ENGINE - NO. 4 BEARING COMPARTMENT - INTRODUCE A NEW NO. 4 BEARING OIL TUBE ASSEMBLY -
CATEGORY CODE 6 - MOD.ENG-72-0168

V2500-ENG-72-0168

Location of the No. 4 Bearing Outer Tube Assembly
Fig.1

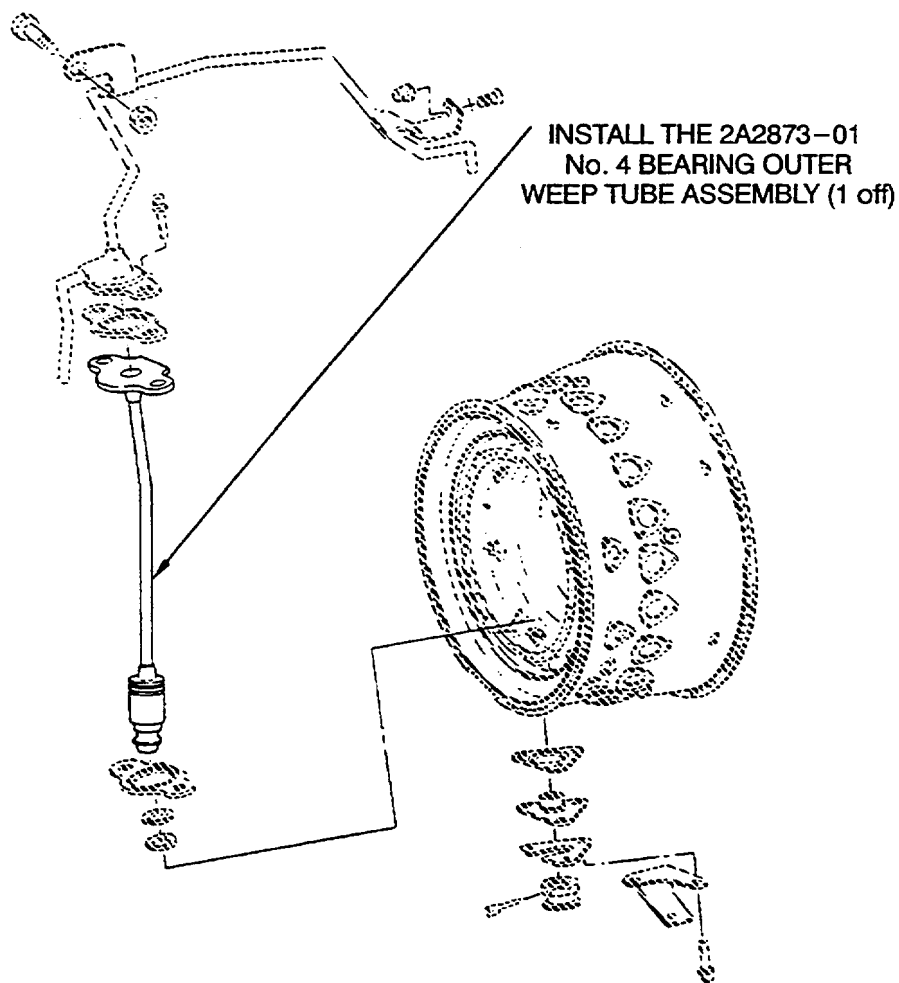
It was possible to have interference between the No. 4 Bearing and Airframe Outer Tube Assembly and the active clearance control linkage. Also, the sealing function did not always operate correctly.

(1) Replace the No. 4 Bearing Outer Tube Assembly with one that has the following features:

(a) A decreased length.

(b) A connector with improved O. D. sealing.

- (1) For V2500-A1 and V2500-A5 Engines
 - (a) Install the 2A2873-01 No. 4 Bearing Outer Weep Tube Assembly (1 off) by the approved procedure given in Reference (2), Chapter/Section 72-42-10, Assembly, and Figure 1.
- (2) For V2500-D5 Engines
 - (a) Install the 2A2873-01 No. 4 Bearing Outer Weep Tube Assembly (1 off) by the approved procedure given in Reference (3), Chapter/Section 72-42-10, Assembly, and Figure 1.
